YMCI Carter Street

Submission to the SOP Master Plan 2030

Prepared for: YMCI
Date: 15 November 2016

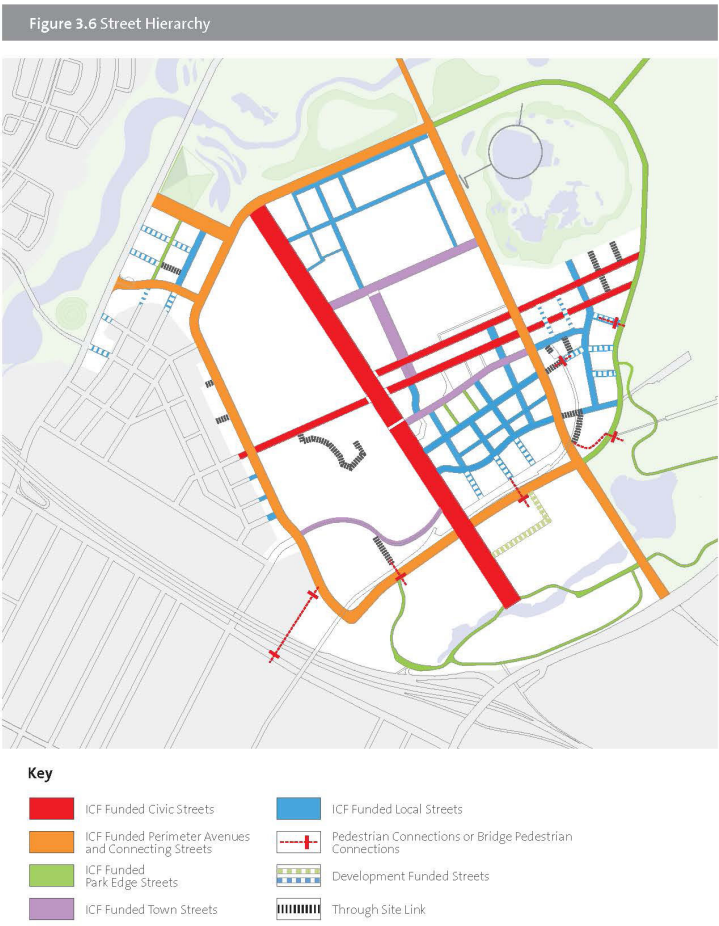
The street hierarchy plan should consider how the Carter Street Precinct integrates with the SOP Master Plan 2030. In particular, Hill Road should be designated as a Perimeter Avenue keeping in character with the streets that ‘frame’ Sydney Olympic Park and function principally for traffic conveyance.

4. Update Figure 3.6 'Street Hierarchy' in the SOP Master Plan 2030 to reflect the function of Hill Road as a 'Perimeter Avenue and Connecting Street'.

Figure 3.6 Street Hierarchy

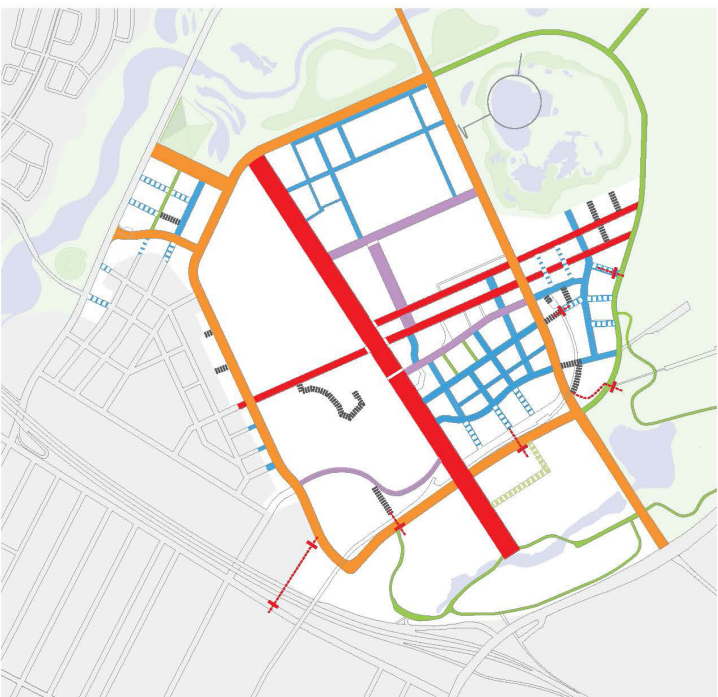
Local street connections from the Carter Street Precinct to Edwin Flak Avenue should be reinstated. Coordinate local street network with the Carter Street Precinct DCP 2016. This will facilitate the range of functions local streets provide and will be important visual connections to iconic structures such as the ANZ Stadium.

1. Revise the SOP Master Plan 2030 to ensure the road layout is consistent with the Carter Street DCP 2016.
2. Upgrade the proposed 'through site links' on the Coach Parking site to local road connections, consistent with the Carter Street DCP 2016.

Figure 3.10 Parking Plan

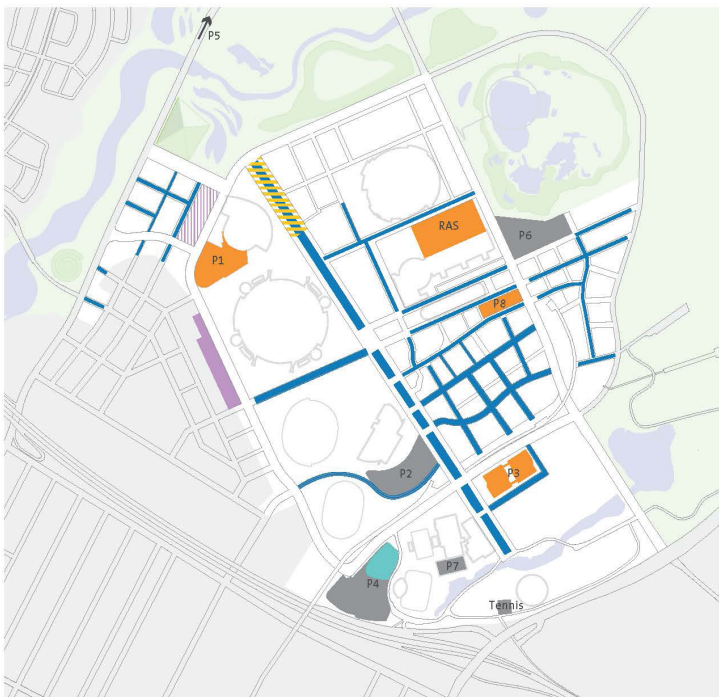
Proposed on street parking for the roads entering the Carter Street Precinct from Hill Road should be removed.

3. Remove the proposed on-street car parking identified in Figure 3.10 'Parking Plan' at the intersection of the Hill Road and John Ian Wing Parade intersection.

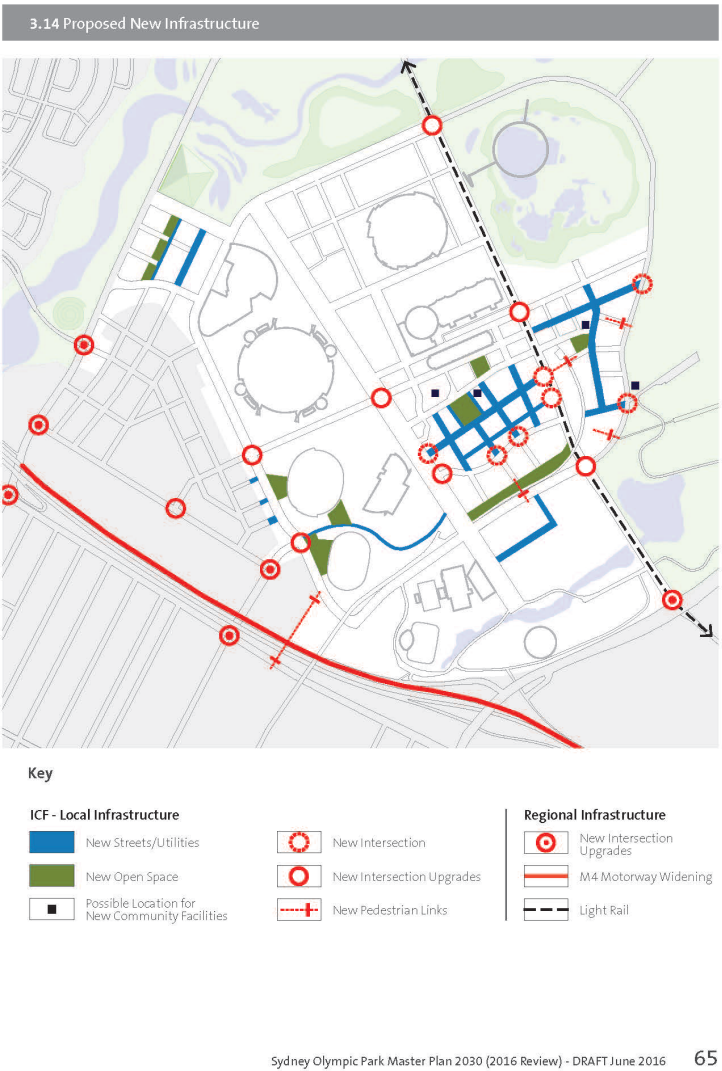
The intersection upgrade plan should consider how this is coordinated with the westbound off ramp from the Westconnex. It is understood that right-hand turning movements northbound on Hill Road into Carter Street will no longer be possible and heavy vehicles will be forced to use local streets within the Carter Street Precinct (refer to the 'Green Link' road in the Carter Street DCP 2016).

The Carter Street DCP 2016 shows future local street connections to Edwin Flack Avenue and designates Hill Road as a primary street. This needs to be coordinated with the proposed traffic functions that service Sydney Olympic Park.

Figure 11 Community facilities plan

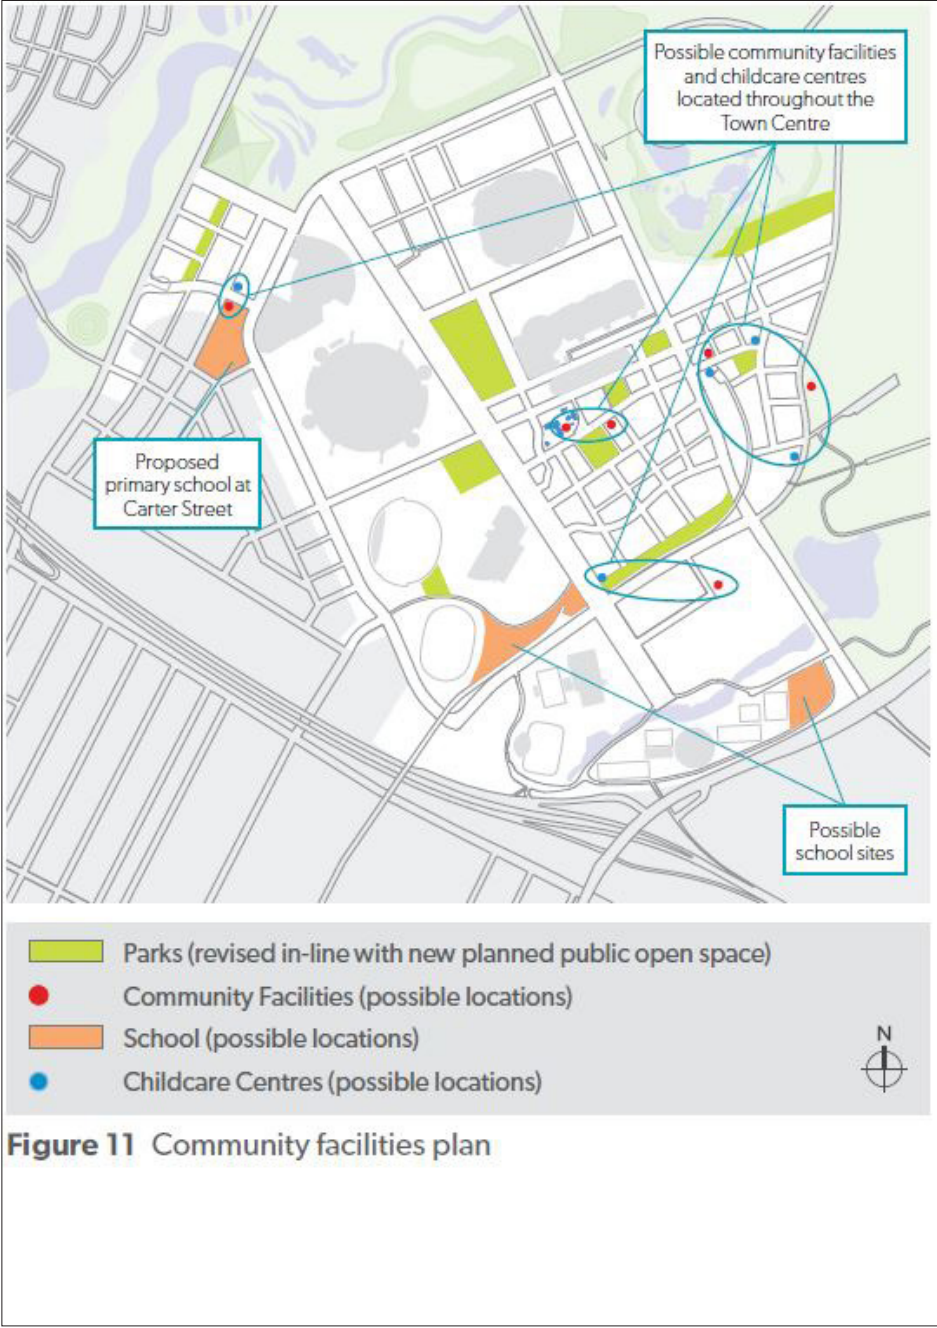
The community facilities plan should show the zoned school site within the Carter Street Precinct. The above plan incorrectly shows the school site in the wrong location.

1. Ensure the location of the Carter Street school site in the SOP Master Plan 2030 is consistent with the land zoned SP2 'School' under the Auburn LEP 2010.
2. Revise the possible sites for a co-located community facility and childcare centre near the Carter Street school site.
3. Remove the proposed road connection through the Carter Street school site, consistent with the Carter Street DCP 2016.

Figure 3.4 Illustrative Uses for the Town Centre

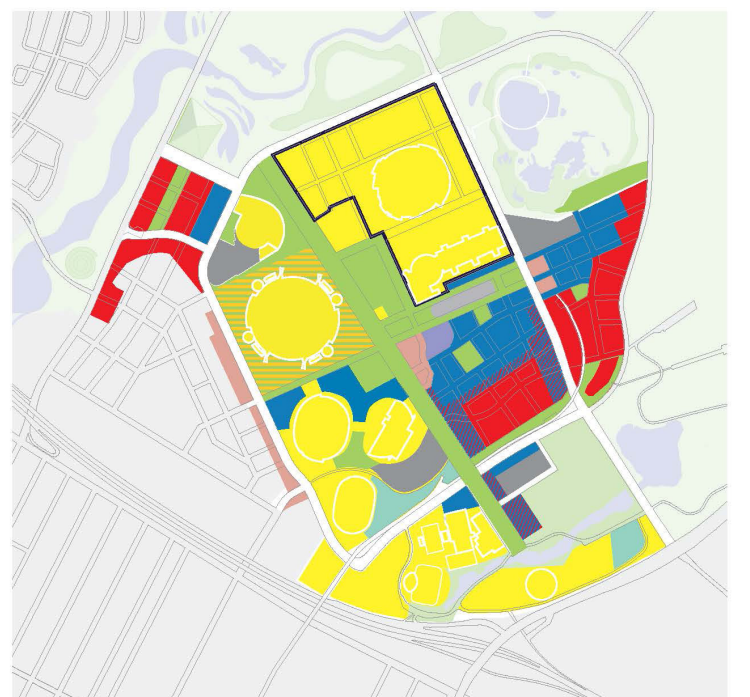
The Carter Street DCP 2016 shows future local street connections to Edwin Flack Avenue and the zoned school site that conflicts with the proposed high density serviced apartment zone on Edwin Flack Avenue with no separation.

1. Review the proposed land uses and building heights for the Coach Parking site to consider any potential privacy or visual impacts on the adjoining Carter Street school site.
2. Amend the proposed zoning for the isolated pocket of land on the Coach Parking site to a zone that is complimentary to the future school uses, such as RE1 Open Space.

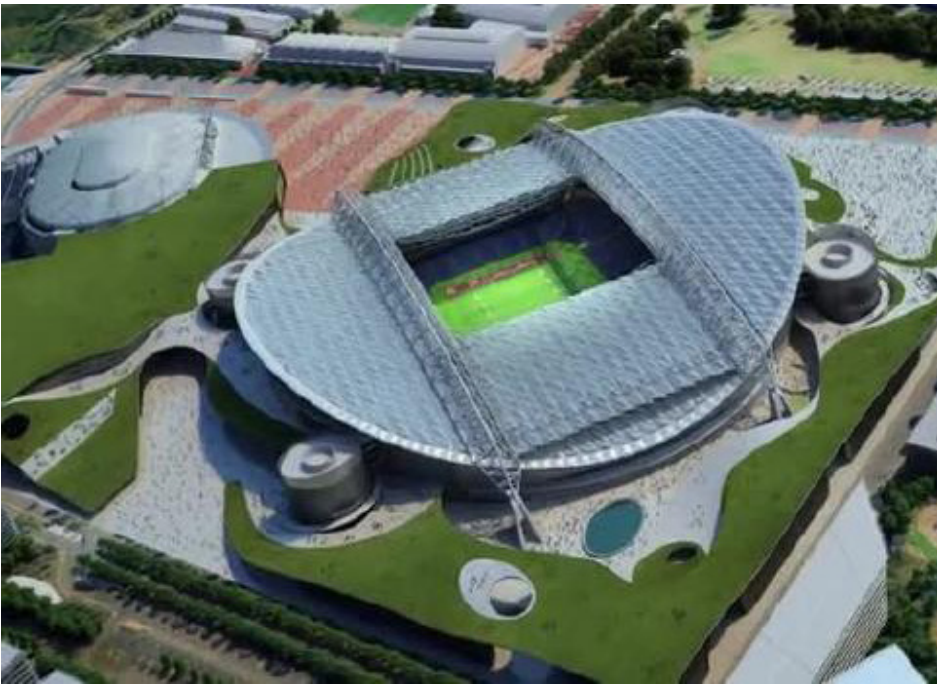
The revised Master Plan proposes infill development around the Stadium and within the plaza. Given the iconic nature of the Stadium and its significance as a landmark for the area, we do not support the proposal to allow infill buildings or structures around the edge of the stadium, but instead recommend leaving the stadium clearly visible from the surrounding public domain.

The proposed infill development around the ANZ stadium is not supported. (image source: BVN Architects)

1. Amend the proposed planning controls to prohibit infill development around the stadium.
2. Develop a public domain strategy to support the SOP Master Plan 2030 and to establish a clear framework to enhance public spaces in Sydney Olympic Park.

Figure 4-3 Acoustic suitability for residential development, over 50m building height

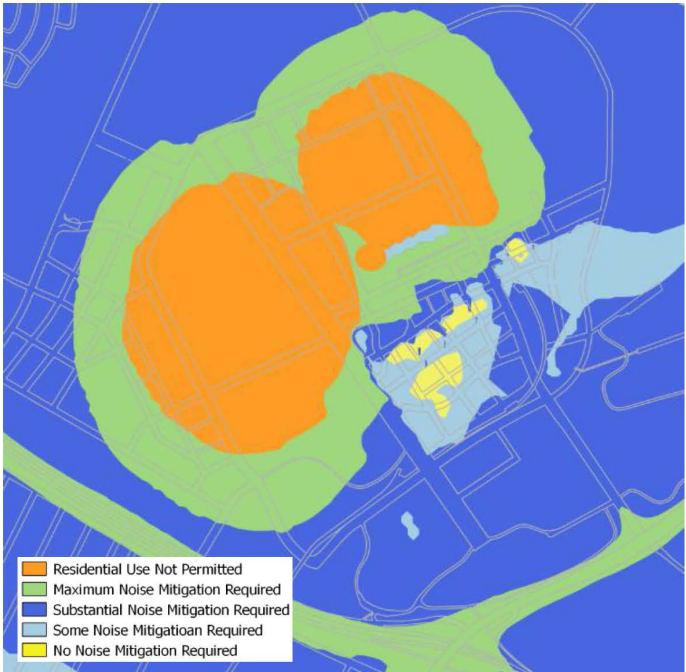
We also note that Figure 4.8 in the SOP Master Plan 2030 does not accurately reflect the extent of noise impacts across the site. The acoustic suitability modelling for residential development over 50m in height must be included to ensure the acoustic suitability modelling is accurately represented in the SOP Master Plan 2030.

The SOP Master Plan 2030 incorrectly shows the noise impact map for 'buildings over 25m' when in fact it is buildings in the range of 25-50m. For buildings over 50m the impact is much greater as shown in the supporting noise management guidelines. This has a large impact on the zoned residential areas within the Carter Street Precinct and needs to be properly coordinated and considered.

1. Review the suitability of the proposed land uses and building heights along Edwin Flack Avenue, consistent with the recommendations of the acoustic assessment and requirements of Section 4.6.15 'Noise Controls'.
2. Update the controls in Section 4.6.15 to include the acoustic suitability modelling for residential development over 50m in height.
3. Consider how the proposed retractable roof structure will assist in noise mitigation for noisy events.
